Product Change Notification - SYST-24DUVO623

ERRATA - PIC24FJ128GA310 Family Errata

Description of Change: Added silicon issue 15

PIC24FJ128GA310 Family Silicon Errata and Data Sheet Clarification

64-Lead Plastic Quad Flat, No Lead Package (MR) – 9x9x0.9 mm Body with 5.40 x 5.40 Exposed Pad [QFN]

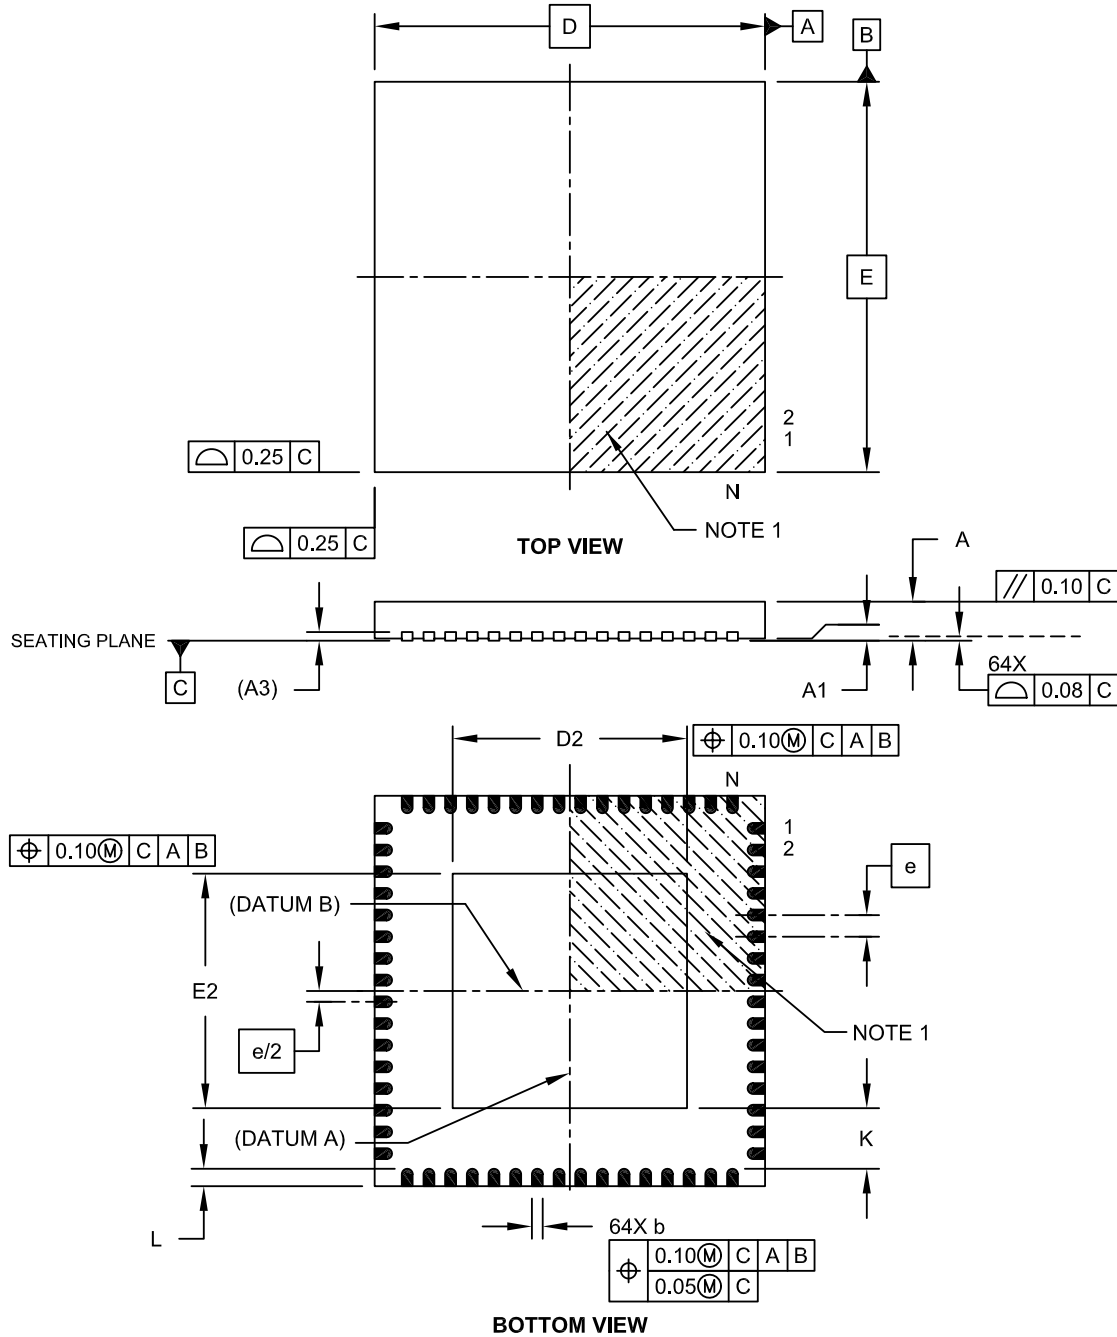
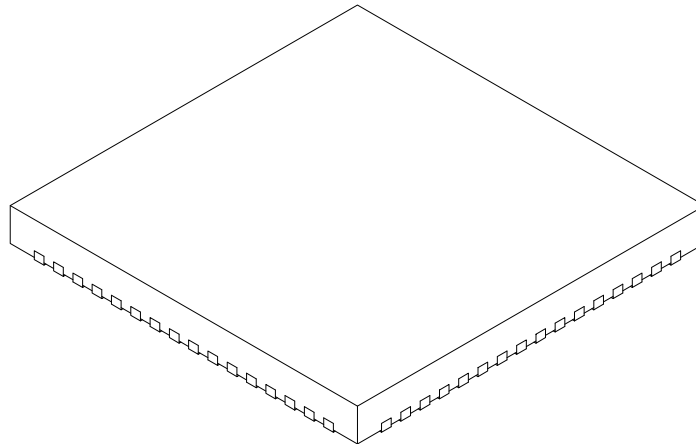
The 64-Lead Plastic Quad Flat, No Lead Package (MR) drawings on Pages 391 through 393 have been replaced with the C04-154A package drawings shown below.
